**1<sup>st</sup> Further Information**

**Proposed Temporary Open Storage of Construction Materials and Machinery and  
Associated Filling of Land for a Period of 3 Years in "Agriculture" Zone,  
Various Lots in D.D. 107, Fung Kat Heung, Yuen Long, New Territories**

**(S.16 Planning Application No. A/YL-KTN/1216)**

**Responses-to-Comments**

SCALE 1 : 5000 @ A4	
DRAWN BY LT	DATE 28.4.2026
REVISED BY	DATE
APPROVED BY	DATE
DWG. TITLE SWEPT PATH ANALYSIS	
DWG NO. PLAN 1	VER. 001

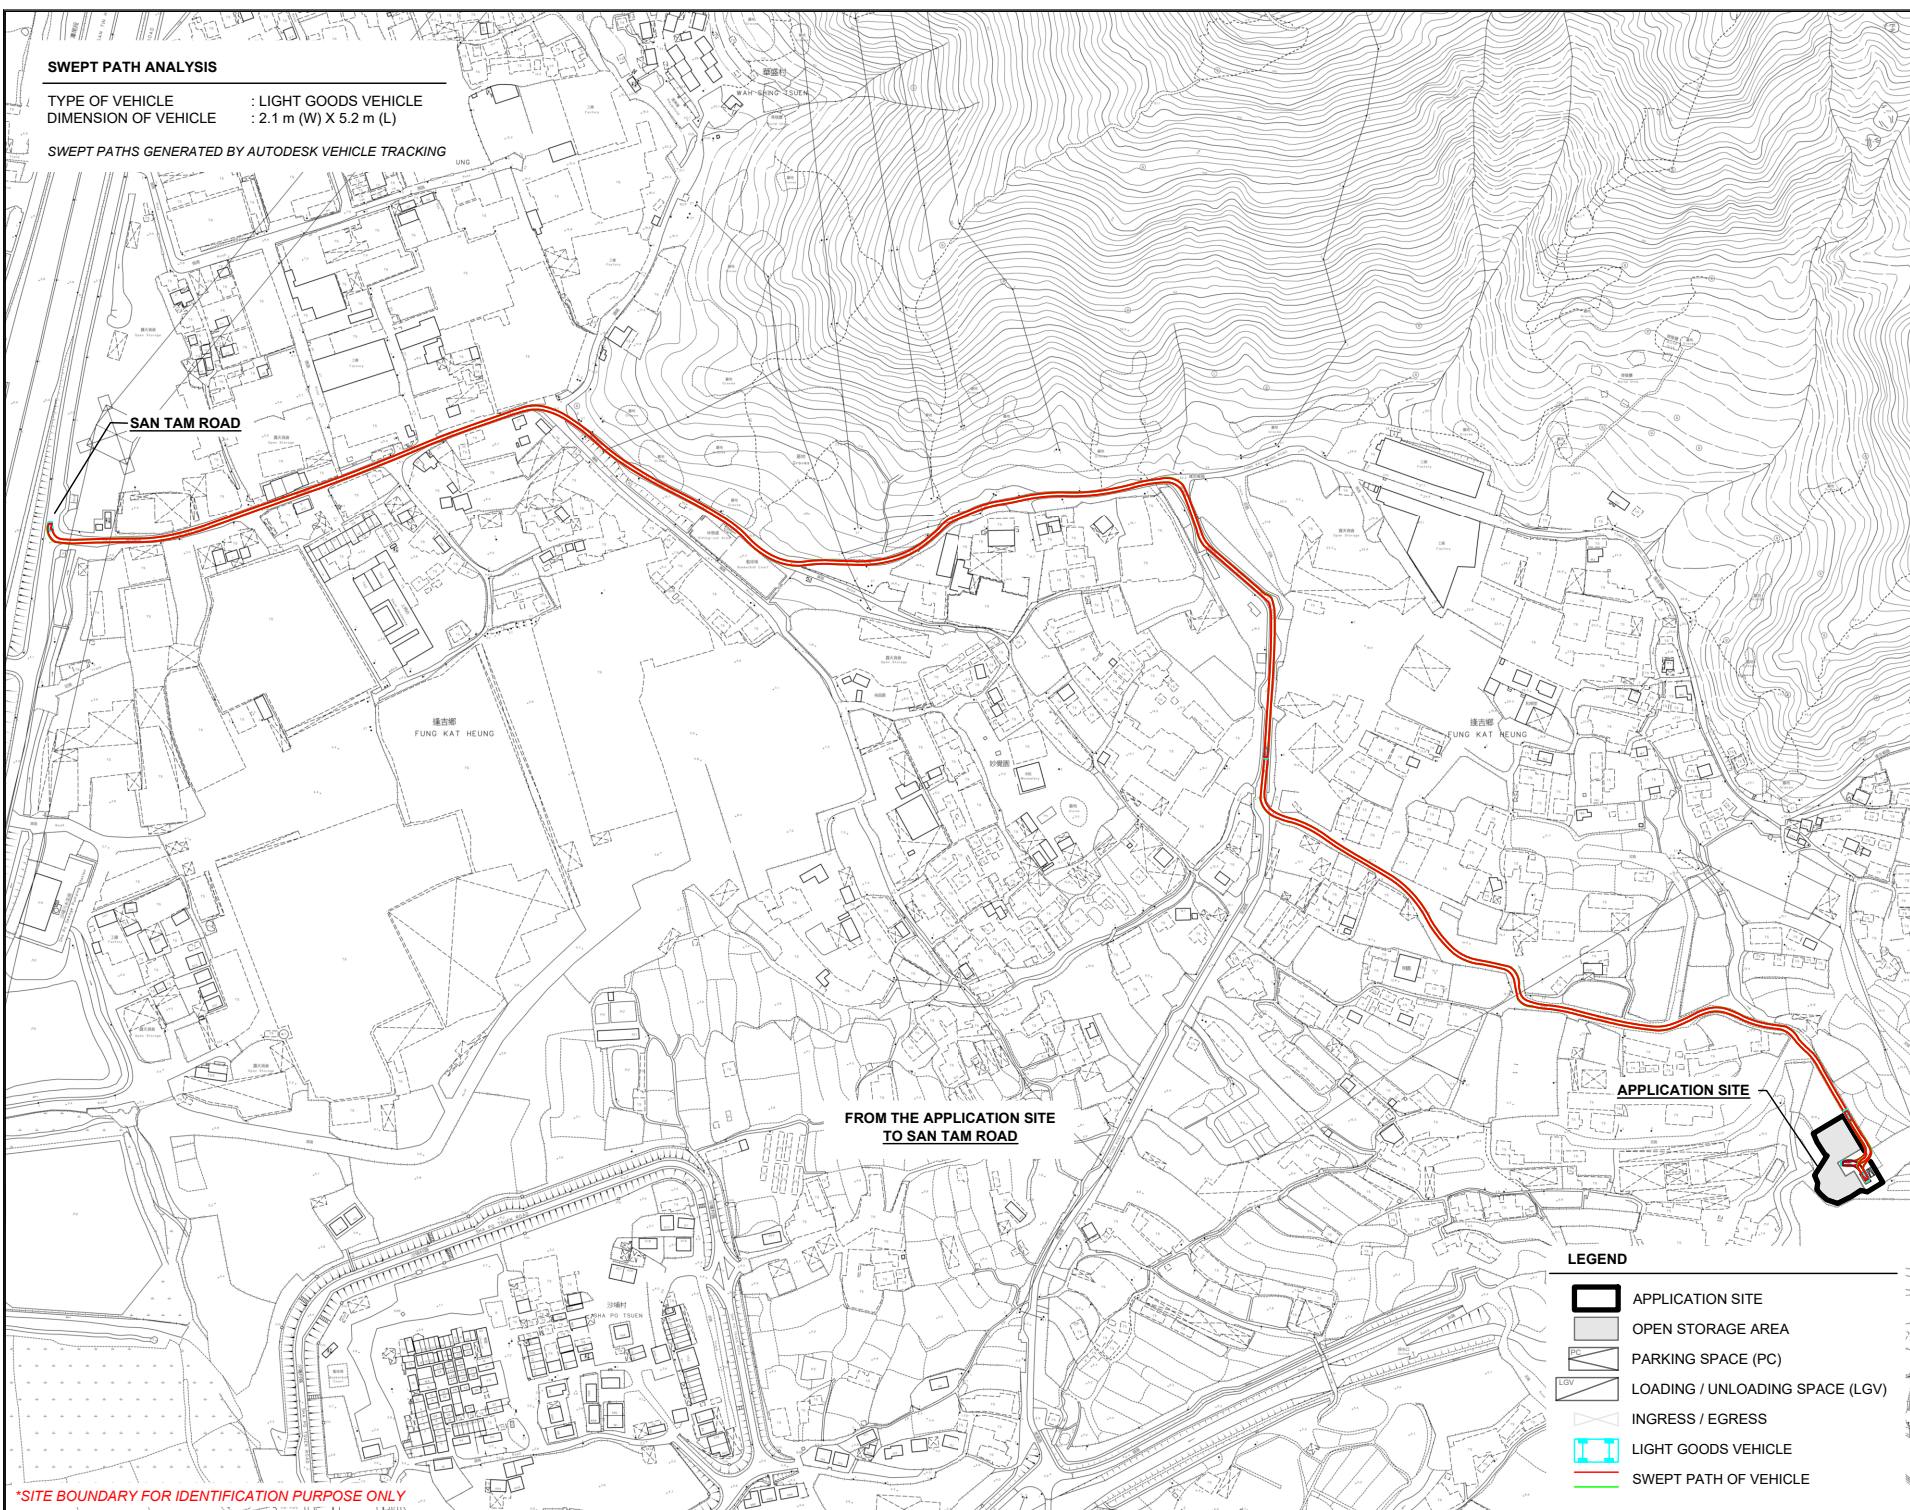
(b)	The applicant should clarify the routing between the public road and the site will be San Tam Road or Castle Peak Road - Tam Mi.	Routing between San Tam Road and the Site is provided ( <b>Plan 1</b> ). Smooth manoeuvring of vehicle to/from San Tam Road via Fung Kat Heung Road, Mei Fung Road and the local access has been demonstrated.

(c)	The applicant should demonstrate the smooth manoeuvring of vehicles to / from San Tam Road or Castle Peak Road - Tam Mi, along the local access and within the site.	
Comments received on 8.4.2026

(a)	The applicant should provide the routing between the public road and the site;	Routing between San Tam Road and the Site is provided ( <b>Plan 1</b> ). Smooth manoeuvring of vehicle to/from San Tam Road via Fung Kat Heung Road, Mei Fung Road and the local access has been demonstrated.

(b)	The applicant should demonstrate the smooth manoeuvring of vehicles to / from public road, along the local access and within the site;	
(c)	The applicant should note the local access between San Tam Road / Castle Peak Road - Tam Mi and the site is not managed by his Department.	Noted.
<b>2. Comments of the Director of Environmental Protection (DEP) (Contact Person: Mr. Kelvin WONG; Tel: 2835 1117)</b>
